SIB 71 02 22

SERVICE ACTION: REPLACE EMISSION CONTROL INFORMATION LABEL (K34)

2022-06-14

This Service Information Bulletin replaces SIB 71 02 22 **dated May 2022**.

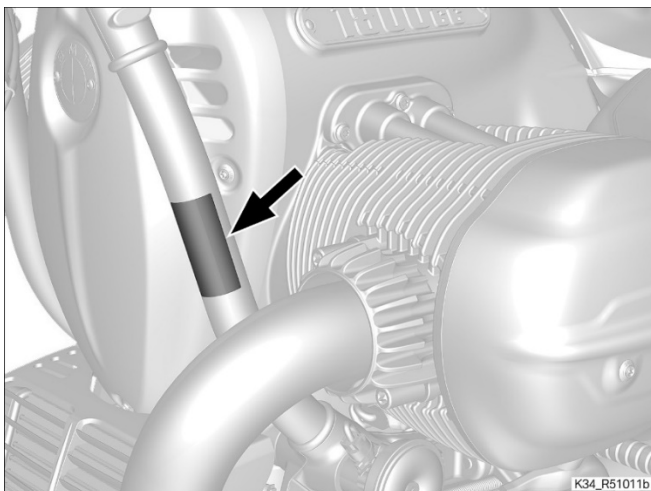
Label "Emission Control Information" contains incorrect information regarding the engine family installed in the vehicle.

Label "Emission Control Information" with the erroneous information must be removed and replaced by the corrected version.

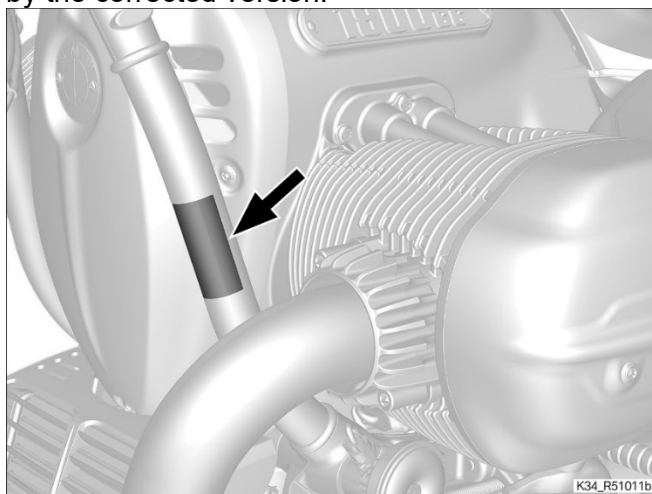
Label "Emission Control Information" contains incorrect information regarding the engine family installed in the vehicle.

Label "Emission Control Information" with the erroneous information must be removed and replaced by the corrected version.
